## **BIDDING ADDENDUM 1**

For work titled:  
Office Space Build-Out

Project Number / Client Number: 24-7022

Plan Sheet A101 – Water Heater Closet Dimensions & Door:

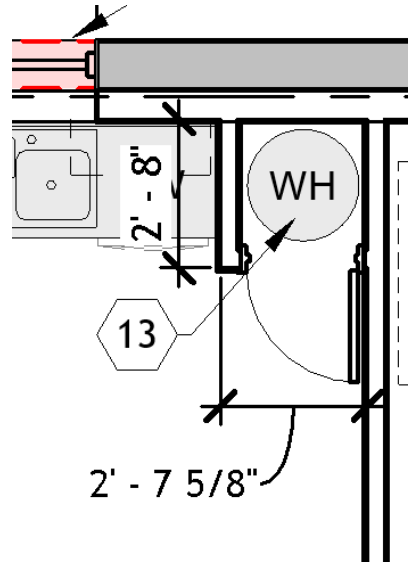
The water heater closet door is a 24"x80" hollow metal door, see detail 2/A102 for details on the frame sizes and types for hollow metal doors. Closet wall construction is typical of other interior walls, dimensions are as noted below.
